# PLANNING COMMISSION

## MEETING AGENDA

**March 12, 2013**

## **Preliminary Site Plan and Special Use Review For City of Troy, Michigan**

ORIGINAL ISSUE DATE: JAN. 10, 2013  
 PEA JOB NO. 2012-211  
 SCALE: 1" = 20'  
 DRAWING NUMBER:  
**P-2**

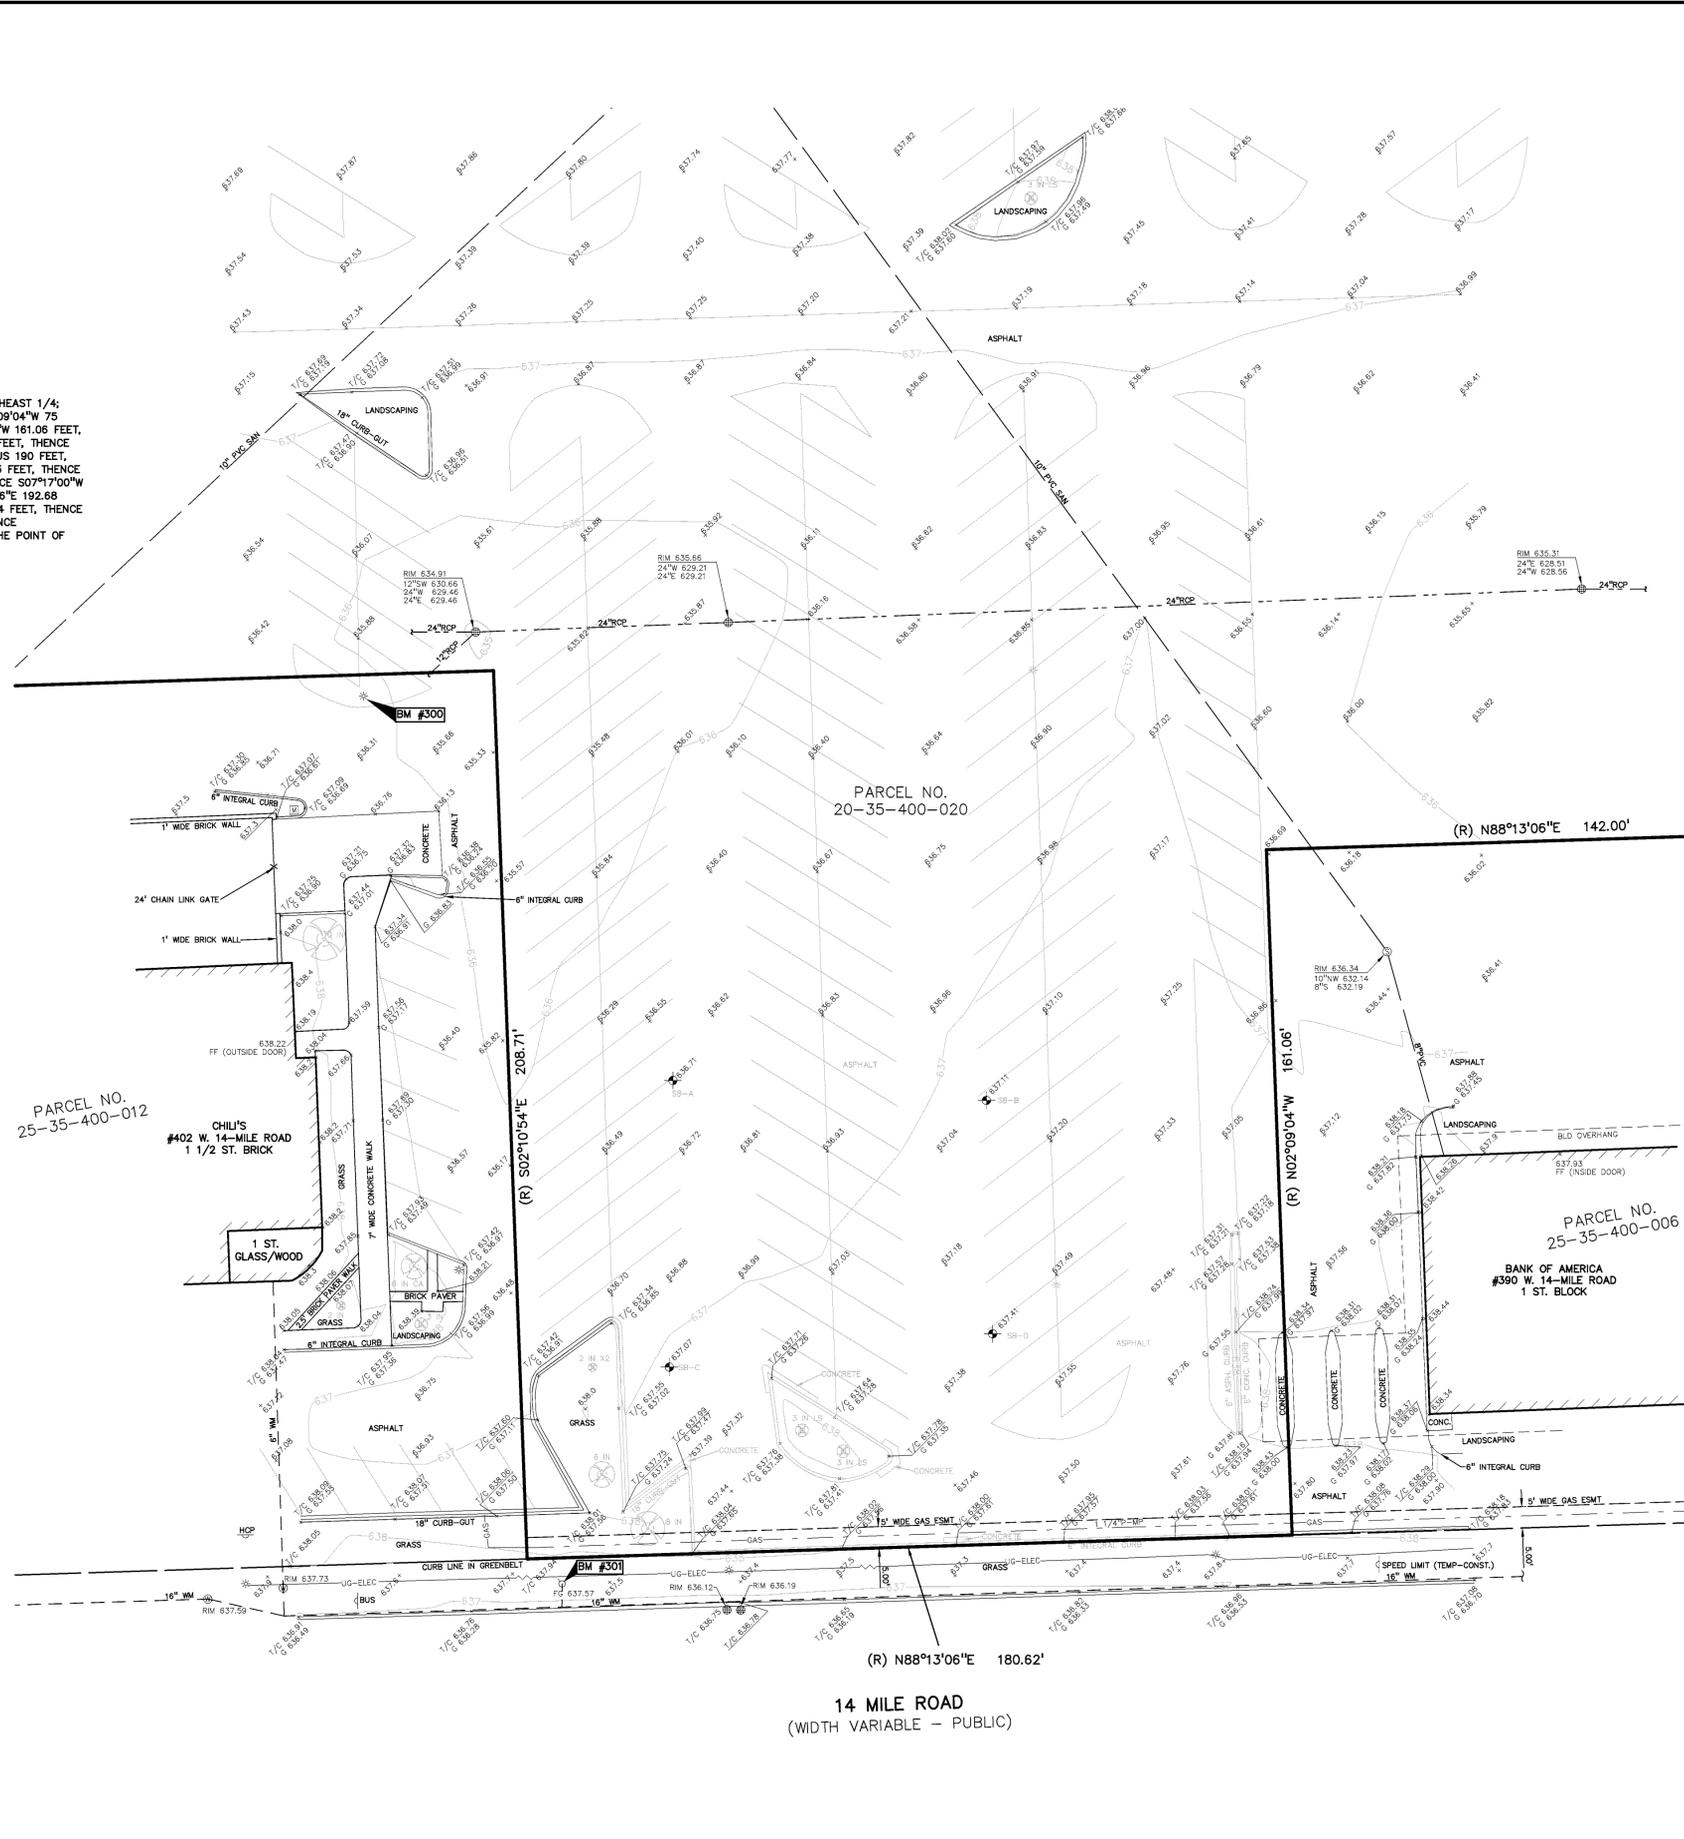
**2. Indicate location of bike rack on site plan.**

**3. Provide a sidewalk along their section of Fourteen Mile road.**

**5. Provide sidewalk and crosswalk to connect the Fourteen Mile sidewalk to the pedestrian ramp.**

The applicant has shown a bike rack on the site plan. The bike rack is located adjacent to the Starbucks outdoor seating area facing the parking lot.

The applicant has shown a 5-foot sidewalk along their section of Fourteen Mile Road. Due to the location of the existing light poles, the sidewalk is partially located outside of the right-of-way and on their property. This sidewalk should be 8-feet in width and if located on their property an easement must be provided. The final location of the sidewalk can be worked out with the Engineering Department and resubmitted for final site plan review.

The applicant has added a sidewalk and crosswalk that connects the Fourteen Mile sidewalk to the pedestrian ramp.

NO.	BY	CHK.	DESCRIPTION	DATE
1	JPB		REVISED PER 2/12/13 PLANNING COMMISSION MEETING	2/15/13

ORIGINAL ISSUE DATE: JAN. 10, 2013  
PEA JOB NO. 2012-211  
SCALE: 1" = 20'  
DRAWING NUMBER:  
**L-1**

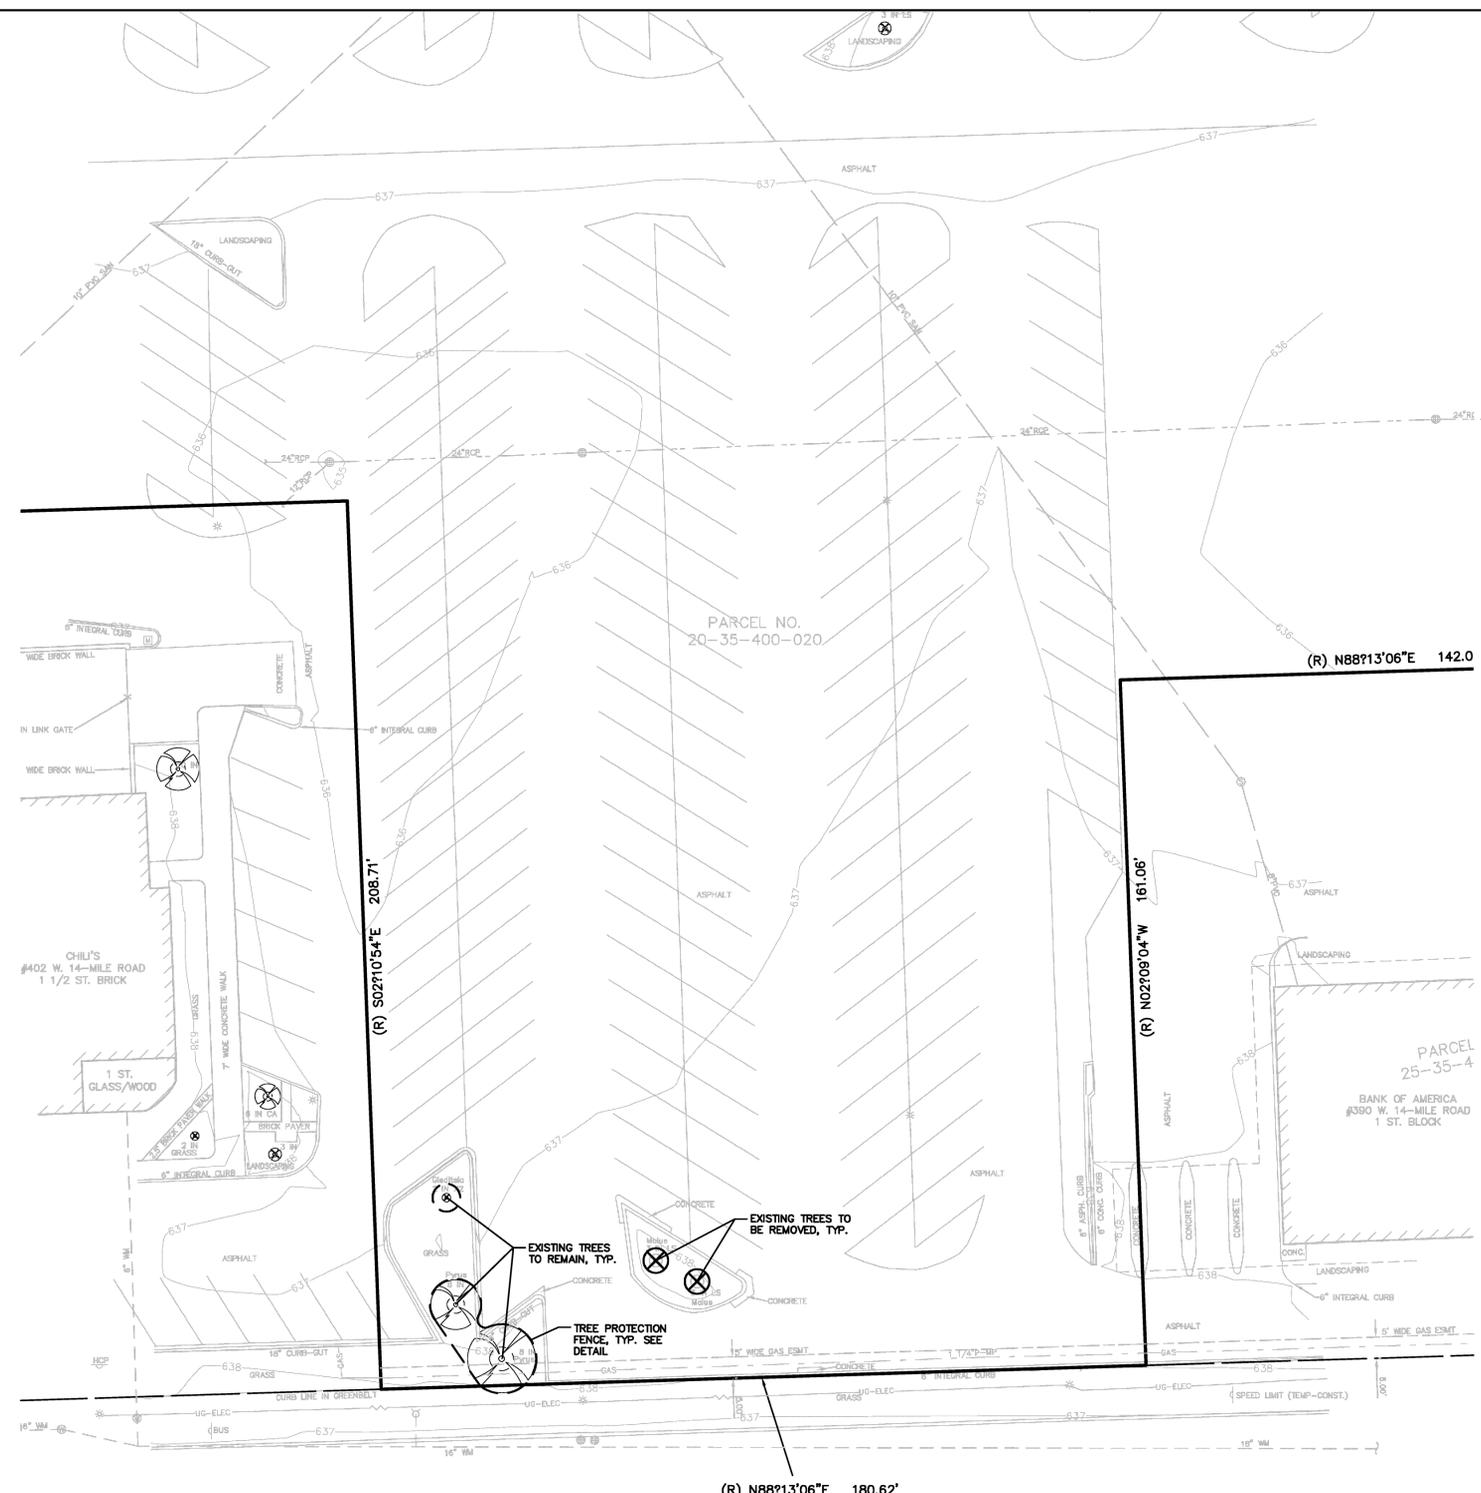
**6. Add one (1) additional parking lot tree.**

The applicant has added the additional one (1) parking lot tree. The provided landscaping is compliant with ordinance requirements.

NO.	BY	CHK	DESCRIPTION	DATE
1	JRB	REVISED PER 2/12/13 PLANNING COMMISSION MEETING		2/14/13
